B.M. ELEV.			
DESIGNED BY	KAS	CHECKED BY	SRB
DRAWN BY	PL	APPROVED BY	DJT
SCALE:	AS SHOWN	RELEASED FOR CONSTRUCTION BY:	R. SOROKOWSKI
NO.	742-2005 ADDENDUM 3	DATE	06/05/05
ISSUED FOR TENDER		DATE	06/02/03
NO.	REVISIONS	DATE	BY
		2005/10/21	
		2006/02/07

THE CITY OF WINNIPEG
WATER AND WASTE DEPARTMENT
ENGINEERING DIVISION
WATER TREATMENT PLANT
FLOCCULATION AND DAF
FOUNDATIONS AND CONCRETE STRUCTURES
PIPE EMBEDS
THIRD FLOOR PLAN AND SECTIONS
CLARIFIED RAW WATER
CITY FILE NUMBER
SHEET OF
CITY DRAWING NUMBER
1-0601P-A-M9103-001-01D

17 THIRD FLOOR PLAN - CLARIFIED RAW WATER SUPPLY LINES FOR SATURATION TANKS; MUD VALVE OPERATORS
WP-M9103 1:150

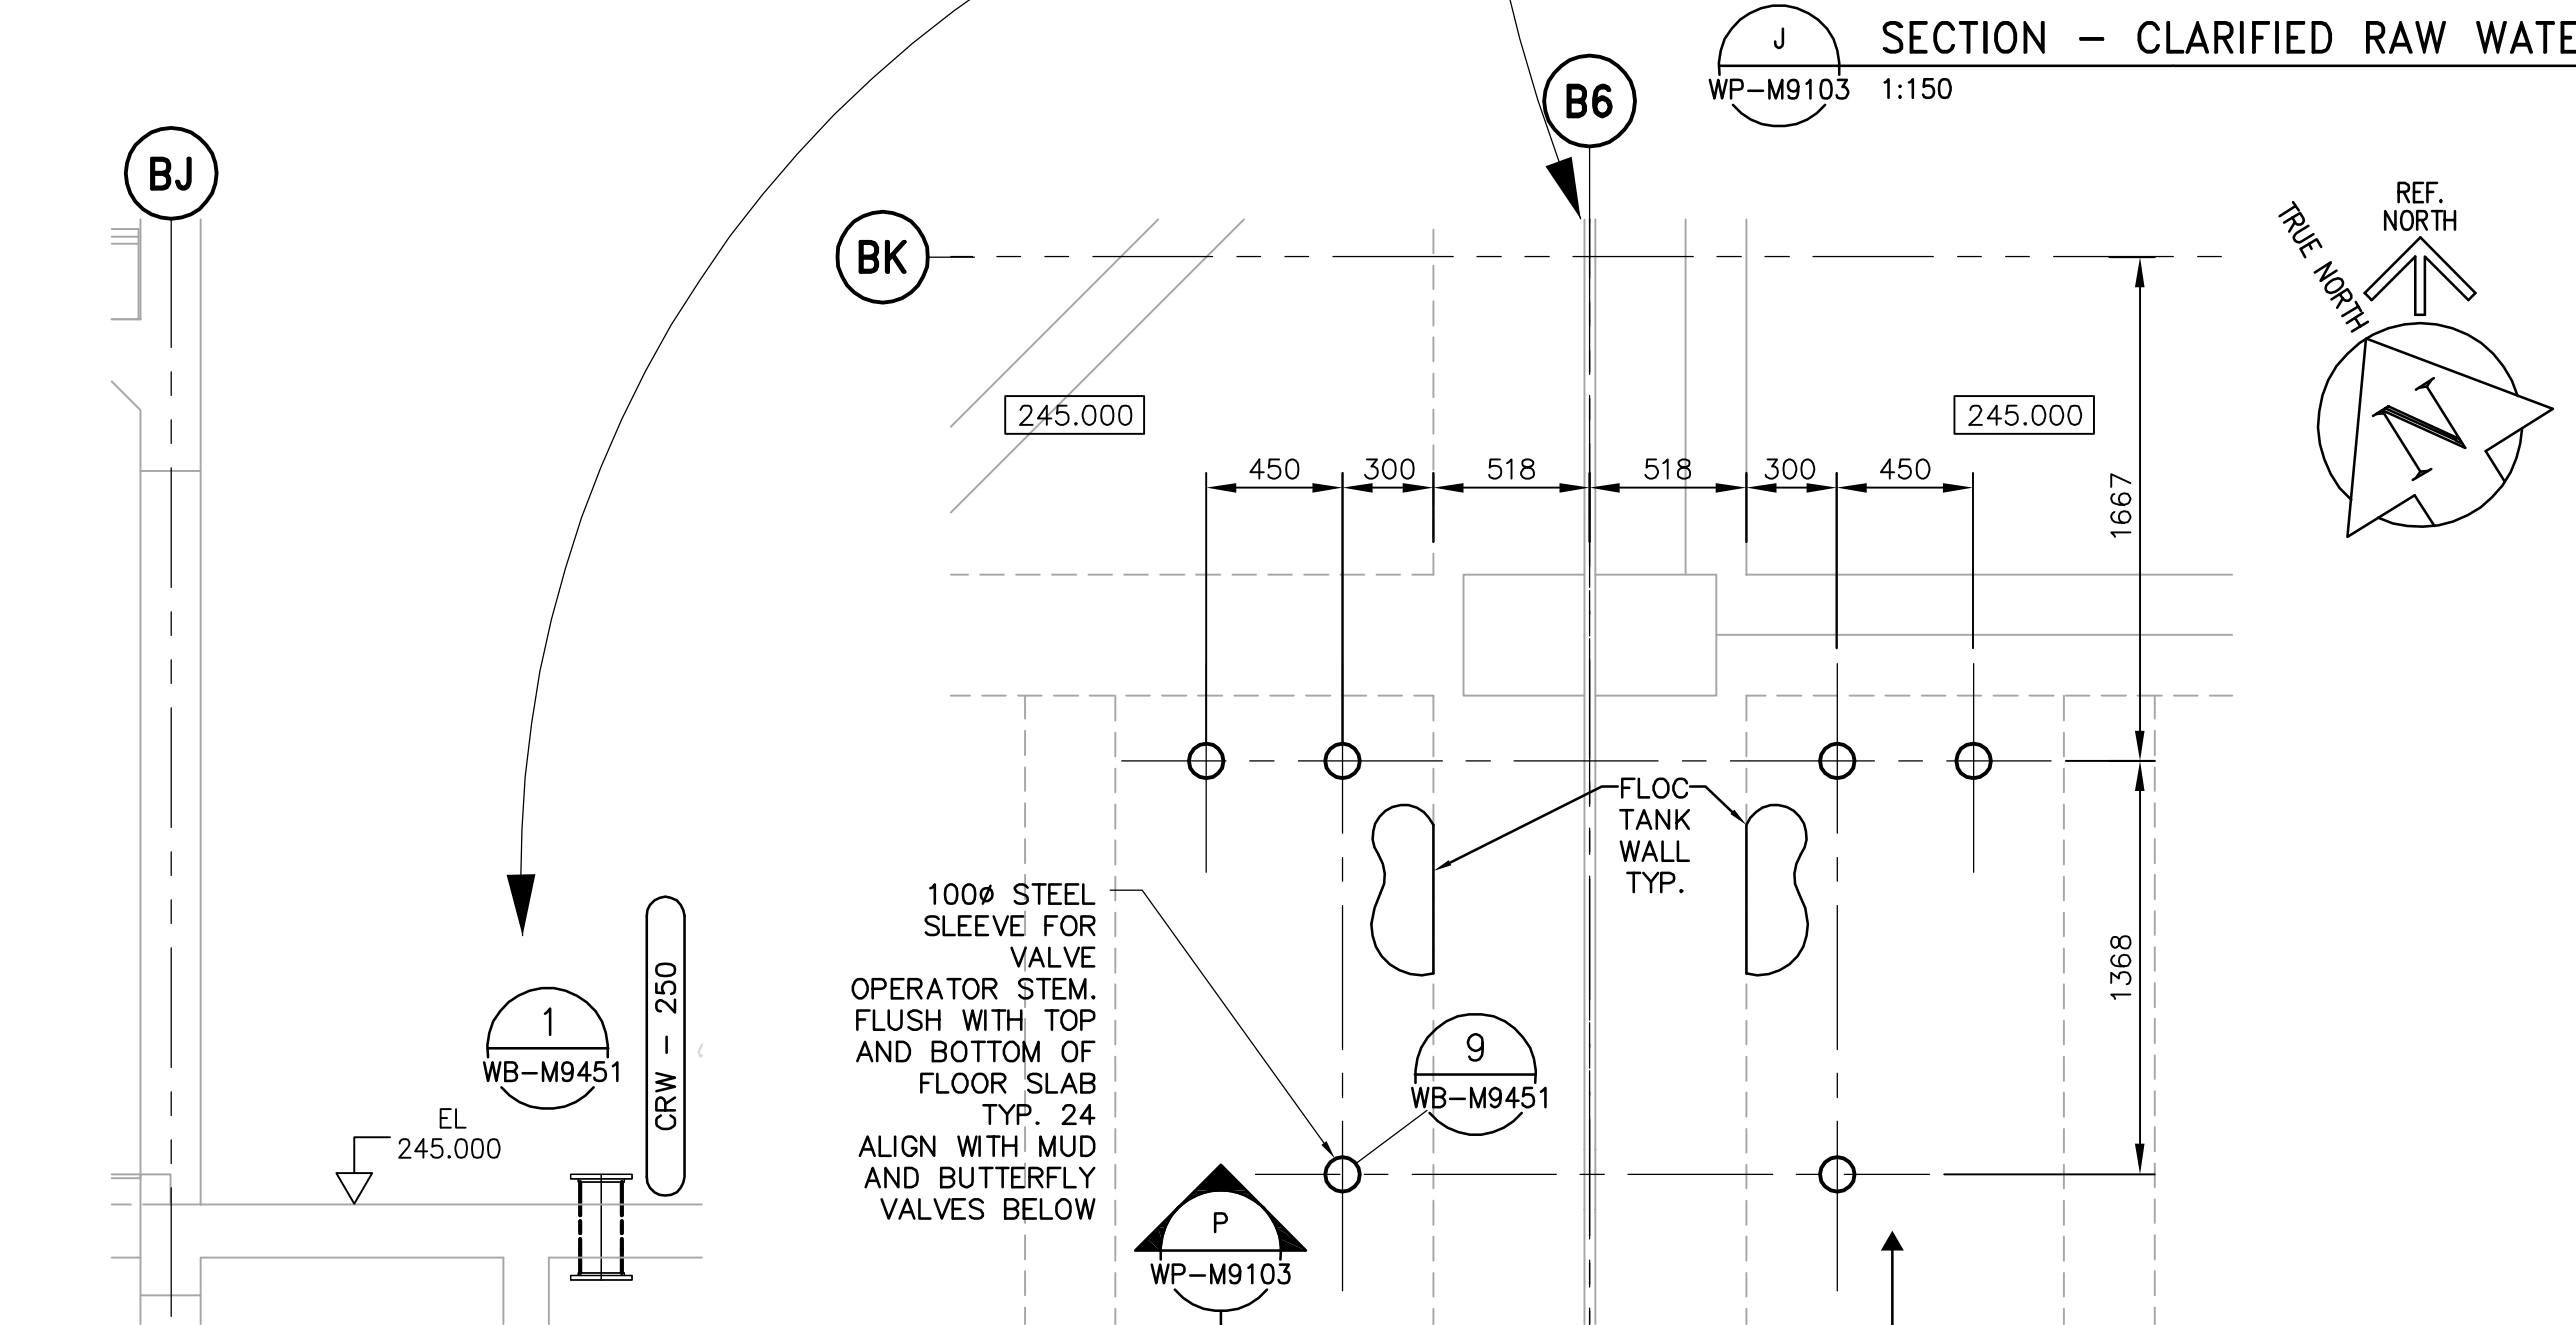
NOTE 1:
PROVIDE SIX PIPE SLEEVES FOR THE CHEMICAL FEED LINES ABOVE THE DOOR. CONFIRM LOCATION WITH CONTRACT ADMINISTRATOR. THERE ARE THREE 38 MM DIA. FERRIC CHLORIDE SCHEDULE 80 PVC LINES AND THREE 25 MM DIA SULFURIC ACID STAINLESS STEEL LINES.

NOTES:
1. PROVIDE 6 PIPE SLEEVES FOR THE CHEMICAL FEED LINES ABOVE THE DOOR IN ACCESS CORRIDOR NUMBER 3. CONFIRM LOCATION WITH CONTRACT ADMINISTRATOR. THERE ARE THREE - 38mm ϕ FERRIC CHLORIDE SCH. 80 PVC LINES AND THREE - 25mm ϕ SULFURIC ACID STAINLESS STEEL LINES. PIPE ELEVATION TO BE 240.270.
